Access Compliance Report

Public Rights-of-Way

(Pedestrian Signals)

Intersection ID: N/A	Main Street:	Cross Street: N/A	Location: N/A
ADA ID: 99835C11F3E4	Signal Type: Two Push Buttons-Non APS	Overall Compliance: No	Severity Score: BTN 1:N/A BTN 2: N/A No BTN: N/A
Codes/Mitigation Info/Possible Solution		Field Measurements/Component Compliance

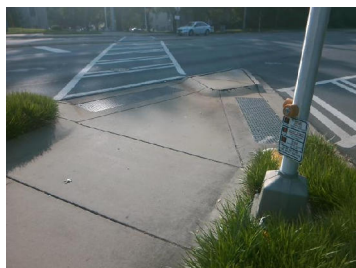
Surveyor Notes: TEXT HT 1/2

PROW/ADA: R410.6, R406.2, R404.7.3,
R209.1, TMUTCD 4e.08

Possible Solutions: Remove & Replace Sign.
Provide Push Button Extension.
